#### Proposals for amendments to RID/ADR/ADN: new proposals

### Misleading graph at the end of 4.1.4.1, packing instruction P200

Transmitted by Liquid Gas Europe\* \*\*

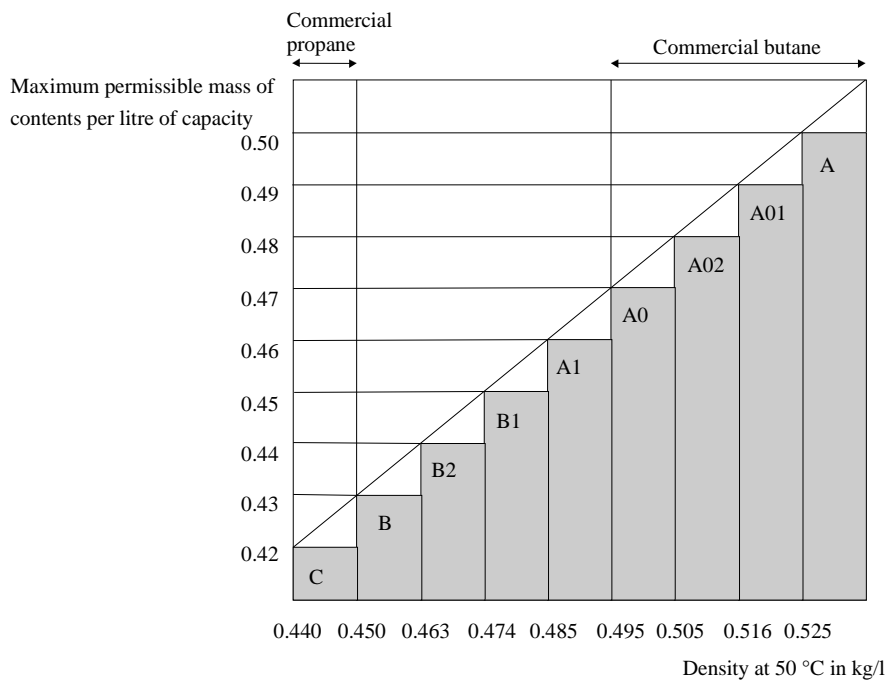
2. The collective entries in 2.2.2.3 do not have a limit on the maximum density of each of the mixtures.
3. The graph at the end of 4.1.4.1, packing instruction P200 has columns that have a minimum and maximum value for the density of each of the mixtures, as follows:

4. The graph above indicates that commercial propane shall have a liquid density at 50 °C between 0.440 and 0.450 kg/l, however a typical commercial propane will comprise of 90 per cent propane and 10 per cent butane, with a liquid density of 0.462 kg/l at 50 °C. Another typical commercial propane will comprise of 95 per cent propane and 5 per cent propene, with a liquid density of 0.449 kg/l at 50 °C, so only just inside the above limit and any increase in the propene content will take it outside of the column limit.
5. If by mistake, an operator classifies a mixture by its density according to the graph in 4.1.4.1, packing instruction P200 it could be put into a cylinder or pressure drum with an unsuitable pressure rating. For example a mixture of 90 per cent propene and 10 per cent

propane has a liquid density of 0.456 kg/l at 50 °C, so classified as mixture B, however when using 2.2.2.3, list of collective entries, it is classified as mixture C.

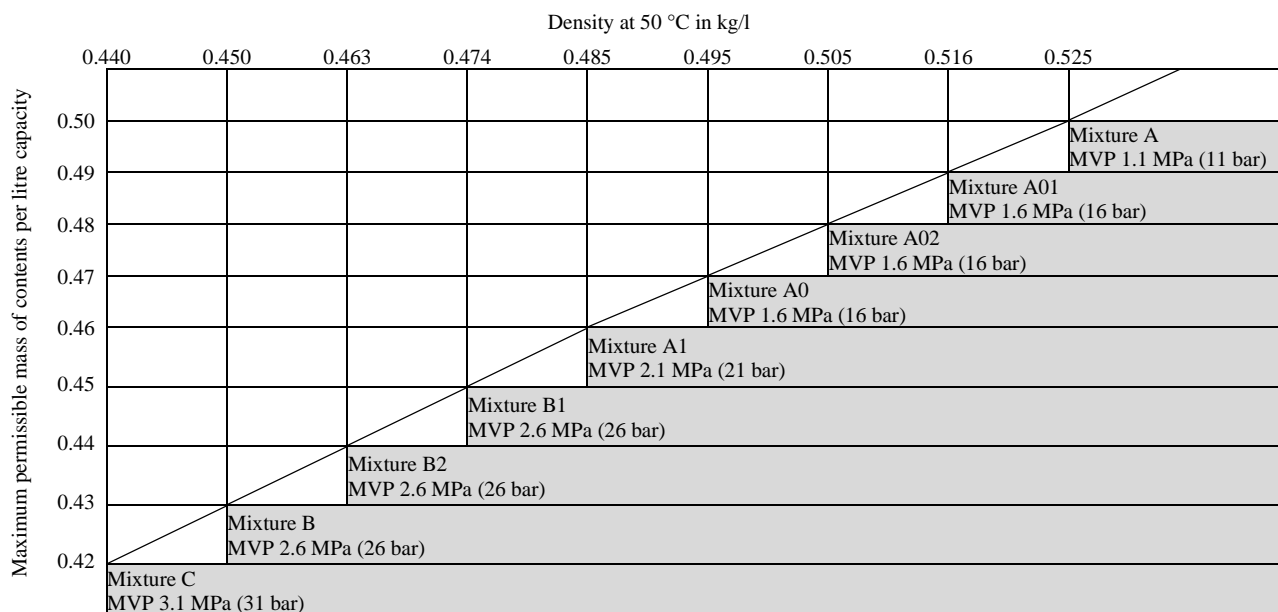
6. In 4.1.4.1, packing instruction P200, after Table 2, replace the existing graph with a new corrected graph as shown below:

MVP = Maximum vapour pressure at 70 °C
